Variance Narrative – Orielle Hotel by Marriott – 102 W. Bay St., Savannah, GA

HOTEL ORIELLE

Design Proposal

PROJECT ID:	0A33813A/2
CLIENT:	ORIELLE HOTEL
ADDRESS:	102 WEST BAY STREET SAVANNAH, GA
DATE:	6/03/2026
CONTACT:	MIKE DRURY
DESIGNER:	LDB

SOUTH ELEVATION

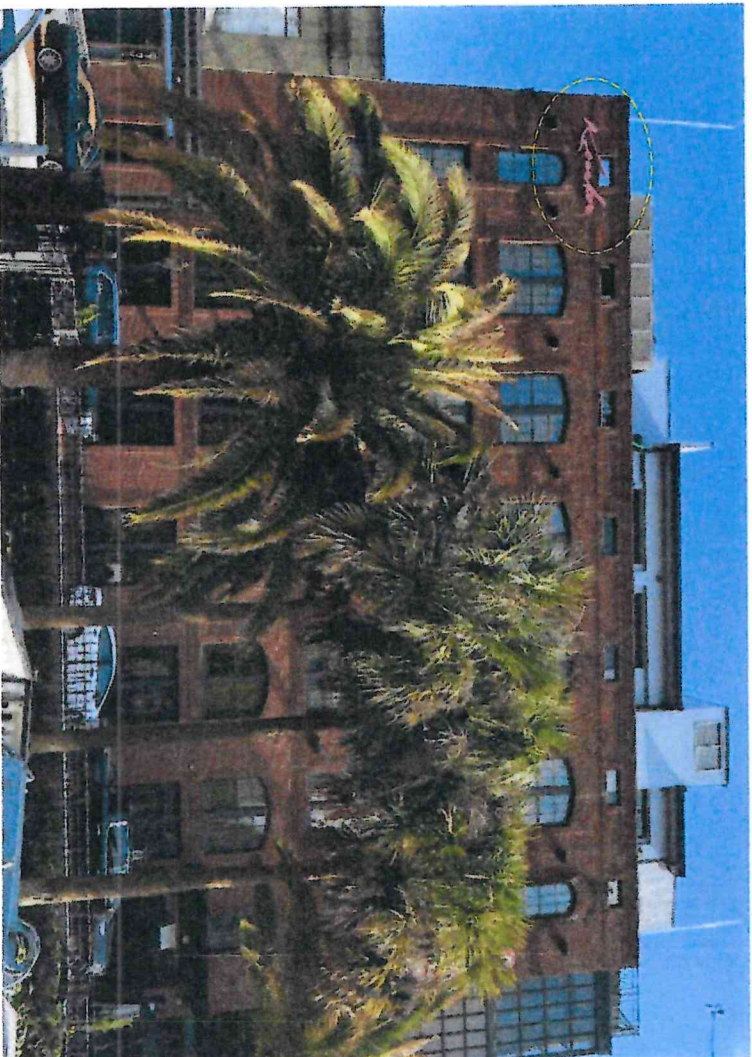
- 1) **Sign Area of 64 sq. ft.** - We are requesting variance from the 30 square foot restriction in order to allow for a more distinguishable design element for this new hotel brand. The actual hotel name copy is virtually identical to the copy area of the existing “Bohemian Hotel”. The only difference is a wider cabinet that allows for the design element and a less “crowded” brand on the sign face. Approval of this variance request will have no negative impact on the district or the surrounding businesses, as the competing hotels directly next door to this property both have existing signs on the same South elevation that are larger than the 64 square feet we are requesting approval for. (Hyatt Regency – 75 Sq Ft and Cotton Sail Hotel – 70 Square feet.)

- 2) **Internal Illumination** – We are requesting variance from the code prohibiting internal illumination. The existing “Bohemian Hotel” sign is currently internally illuminated, as are both the Cotton Sail Hotel and the Hyatt Regency, our competitors directly next door. Enforcing the restriction of prohibiting the internal illumination will cause an undue hardship to The Orielle not enforced or applied to either the Hyatt Regency or the Cotton Sail Hotel. Approval of this variance request will have no negative or adverse impact on the district, as we are simply requesting to continue allow the same illumination that is currently in place and that the competing hotels currently have.

- 3) **Sign Location on Building** – We are requesting variance in order to install the new sign in the same location the existing “Bohemian Hotel” sign is located. Requiring the sign to be installed at the “top of the building” or the “top of the first floor” would create hardship and compromise the integrity of the architectural design of the building, as these locations have critical design elements and brick accents that would be sacrificed if the sign is required to be placed in these locations. The building also has driveway entry arches, palm trees and front entrance canopy that would effectively block all visibility of a sign installed at the top of the first floor. Approval of this variance request will have no negative impact, as it simply a request to allow the new sign to be installed in the same location as the existing sign and Cotton Sail Hotel has their sign on the top of the SECOND floor without any of the visibility hindrances the Hotel Orielle has.

Wall and projecting signs in the Downtown district are required by Sec. 9.9.17.g.xv.1.c to be in the signable area. The “Orielle” sign on the south side of the building does not comply with this requirement. Please confirm that you would like to add this section to your variance request.

Yes, please add this to our variance. Thank you so much.
